# Access Compliance Report

## Public Rights-of-Way

### (Curb Ramps)

Intersection ID: 6143	Main Street: COREOPSIS_RD	Cross Street: YARROW_RD	Location: NW
ADA ID: 3AD86939A928	Ramp Type: Perp	Initial Pass/Fail: Fail	Overall Compliance: No
Codes/Mitigation Info/Possible Solution		Field Measurements/Component Compliance	
Severity Score: 46.25

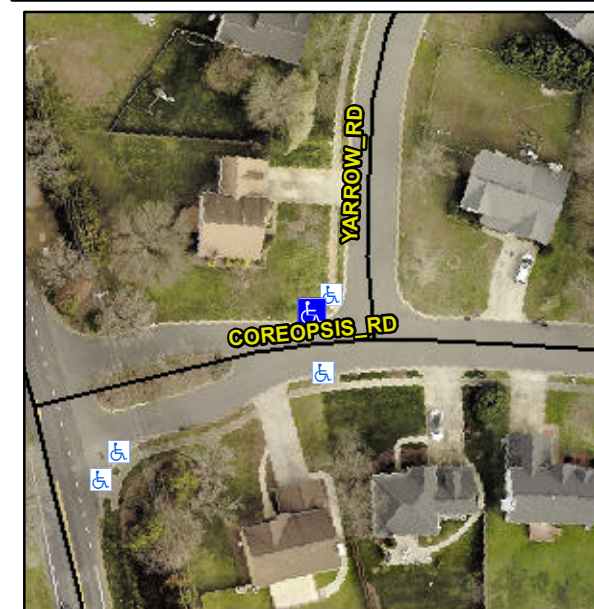
**Not Found, R304.5.1, R304.2.2, R304.5.3**

Compliance	Description	Data	Compliance	Description	Data
N/A	Ramp Length (in)	54.0	No	Ramp Slope (%)	11.2
No	Ramp Width (in)	47.5	No	Ramp XSlope (%)	7.0
N/A	Flare Type LT	N/A	N/A	Flare Type RT	N/A
N/A	Flare Slope LT (%)	N/A	N/A	Flare Slope RT (%)	N/A
N/A	Flare Traversable LT?	N/A	N/A	Flare Traversable RT?	N/A
N/A	Landing Length (in)	N/A	N/A	DWS Provided?	N/A
N/A	Landing Width (in)	N/A	N/A	DWS Contrast?	N/A
N/A	Landing Slope (%)	N/A	N/A	DWS Length (in)	N/A
N/A	Landing X Slope (%)	N/A	N/A	DWS Full Width?	N/A
N/A	Landing Curb? (Y/N)	N/A	N/A	DWS Offset (in)	N/A
N/A	Shared Landing?	N/A			
N/A	Gutter Ponding?	N/A	N/A	Gutter Slope (%)	N/A
N/A	Gutter Lip Ht (in)	N/A	N/A	Gutter X Slope (%)	N/A
N/A	Painted X Walk1?	No	N/A	Painted X Walk2?	N/A
	X Walk 1 Direction	To S		X Walk 2 Direction	N/A
N/A	X Walk 1 Width (in)	N/A	N/A	X Walk 2 Width (in)	N/A
	X Walk 1 Slope (%)	0.7		X Walk 2 Slope (%)	N/A
	X Walk 1 X Slope (%)	5.6		X Walk 2 X Slope (%)	N/A

**Remove & Replace Entire Ramp.**
